## **Important Notices**

## **Restriction on Use of 8-bit Timers**

## Datasheet Modifications: PWM Cycle of 8-bit Timers

Example when using PWM mode

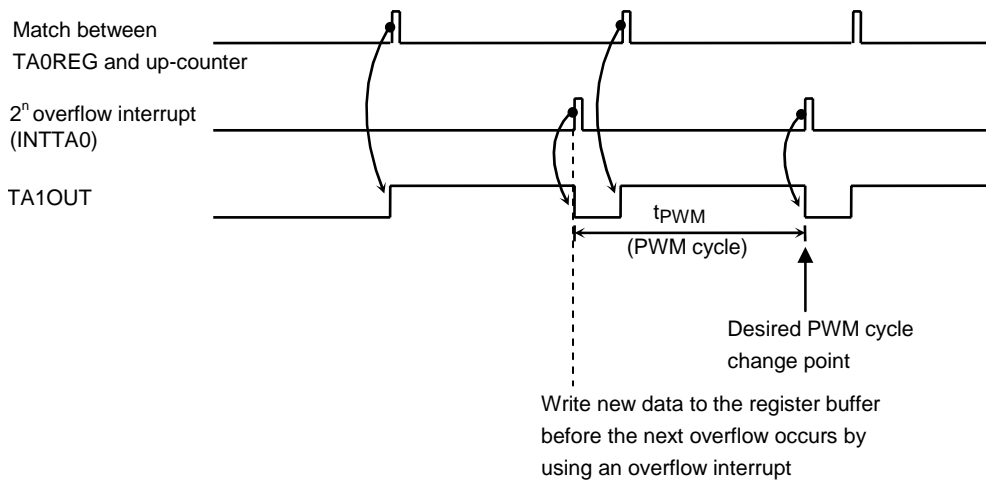
When the double buffer is enabled for an 8-bit timer in PWM or PPG mode, caution is required as explained below.

If new data is written to the register buffer immediately before an overflow occurs by a match between the timer register value and the up-counter value, the timer flip-flop may output an unexpected value.

For this reason, make sure that in PWM mode new data is written to the register buffer by six cycles ( $f_{sys} \times 6$ ) before the next overflow occurs by using an overflow interrupt.

In the case of using PPG mode, make sure that new data is written to the register buffer by six cycles before the next cycle compare match occurs by using a cycle compare match interrupt.
